From: Griffin, Tim (Contractor)
Sent: 02 July 2026 11:22
To: Altman, Rebecca
Cc: Chapman, Gregg (Contractor); Oliveira, Marta (Contractor); Dyer, Tim; Ellison, Mark
Subject: Re: DC/26/100786 play area design - landscape comments

I have now reviewed the submitted play area plan prepared by Deacon Design DD525L34.

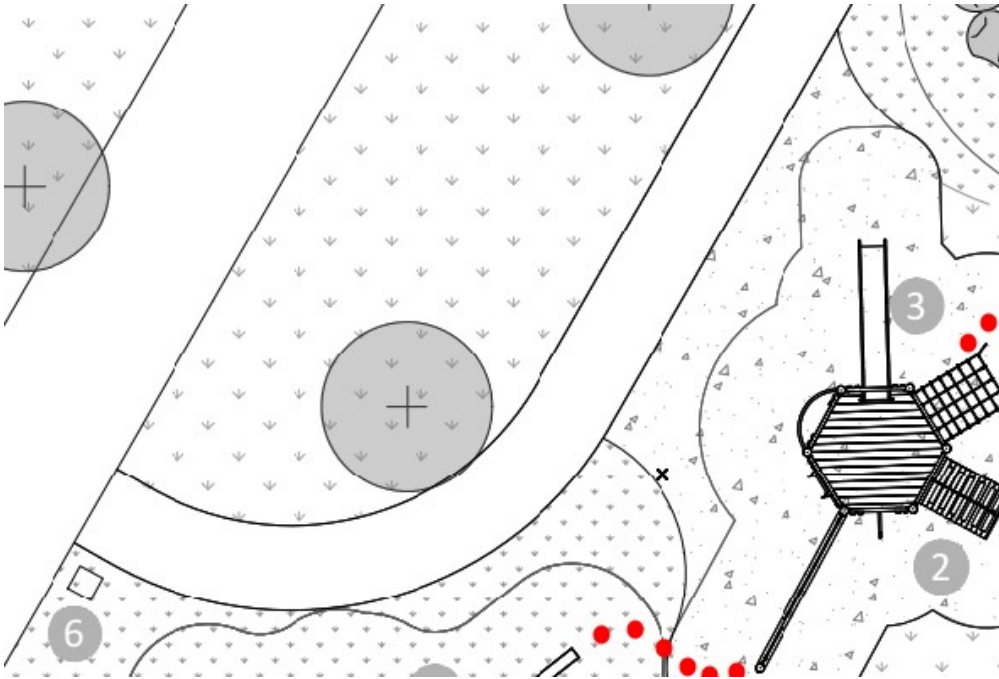
a/ The surfacing indicated for play items 1-4 is not included on the key and should be added.

b/ The den building area item 8 - I am not clear how this area will work in reality. Please provide further details. Where will the den building materials come from? My concern is that this becomes an under-used space and could perhaps be replaced with a more user-friendly play item.

This area is noted as closely mown lawn. Will this area become a muddy and the surface deteriorate during wet winters/springs (same applies to area around item 5)? Alternative all-weather surfaces should be considered, such as reinforced grass.

c/ It would add play value if we could 'link' some of the play items with vertically placed logs to create a 'stepping stone' type balancing challenge as per my markup below:

The logs can be various diameters/heights. Stepping stones would be an alternative.

d/ The arrangement of glacial boulders requires further thought. Generally, groups of 3 or 5 boulders will be more effective, and they should have varied size and form to mimic a more natural effect. Locating some of these on the edge of planting would work well and help the effect be more naturalistic.

e/ Please provide images of the benches indicated. They should be sympathetic to the character of the play area. Once we have seen images of the play items the appropriateness of the Derby bins can also be considered.

I propose the locations of benches are re-jigged as below:

The bench adjacent the planting will need to have an area of hard standing below. This location will be adjacent a specimen tree (I am providing separate comments on the tree planting and suggest this tree is a Sweet Gum).

f/ The species rich grassland will presumably be infrequently mown. For neat effect, a mown grass margin should be introduced along the sides of paths and around seats and bins.

g/ The plant species mix is limited and needs to be improved. Emphasis should be placed on robust species with the introduction of taller grass species, some evergreen ornamentals interplanted with perennial species.
